Re: ***Work Plan for Additional Site Assessment***
76 Service Station # 1156
4276 MacAuthur Blvd
Oakland, CA

RE: **WORK PLAN FOR ADDITIONAL
ASSESSMENT
4276 MacArthur Boulevard
Oakland, California**

Subject: Fuel Leak Case No. RO0000409 and Geotracker Global ID T0600102279, Unocal #1156, 4276 MacArthur Boulevard, Oakland, CA 94619 – Site Investigation Report

FIGURE 4
 SOIL VAPOR POINT
 CONSTRUCTION DETAIL
 76 SERVICE STATION NO. 1156
 4276 MACARTHUR BOULEVARD
 OAKLAND, CALIFORNIA

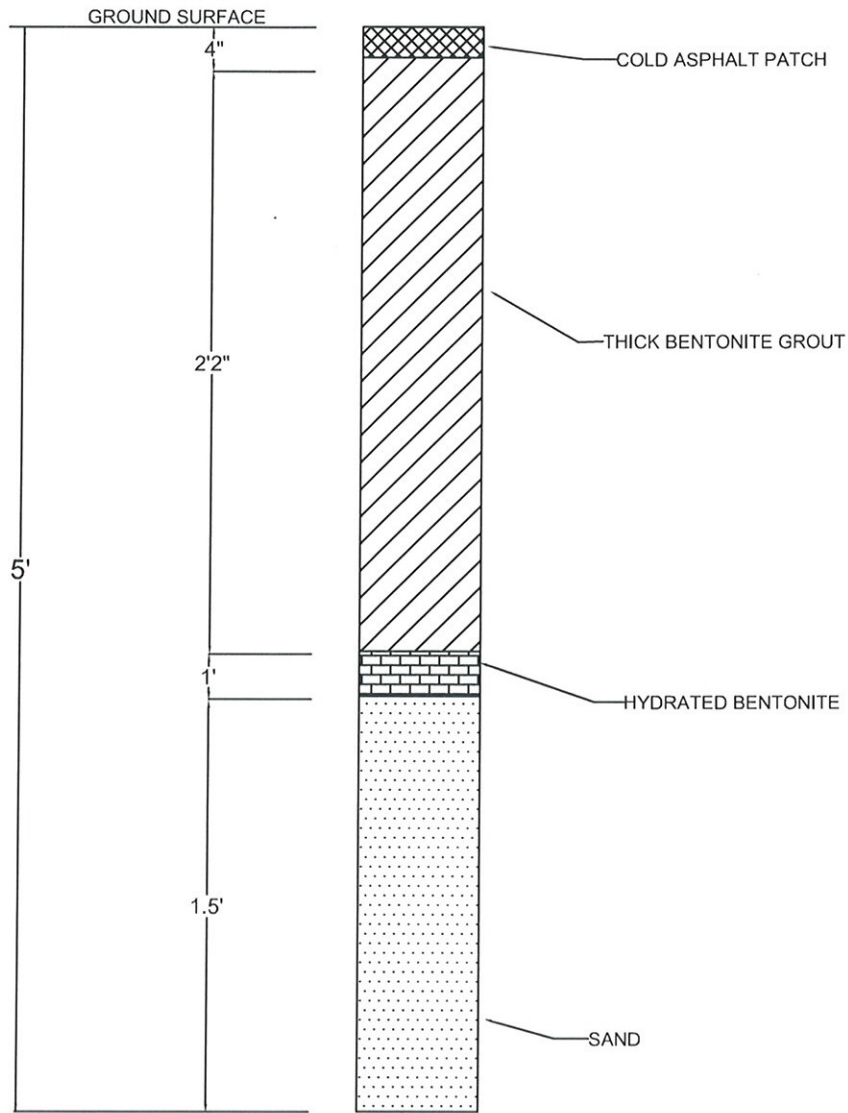
5. **Figure 3.** The diagram in Figure 3 includes only depths and filter pack materials and does not show the soil vapor point. In future documents, please show soil vapor sampling point details.

The boring will be backfilled as follows: #30 or equivalent sand from five (5) feet to 3.5 feet bgs, granular bentonite granules hydrated in place from 3.5 to 2.5 feet bgs, thick bentonite grout from 2.5 feet bgs to just below existing surface, and a thin layer of cold patch asphalt to grade. A construction detail of the proposed soil vapor point is included on Figure 4.
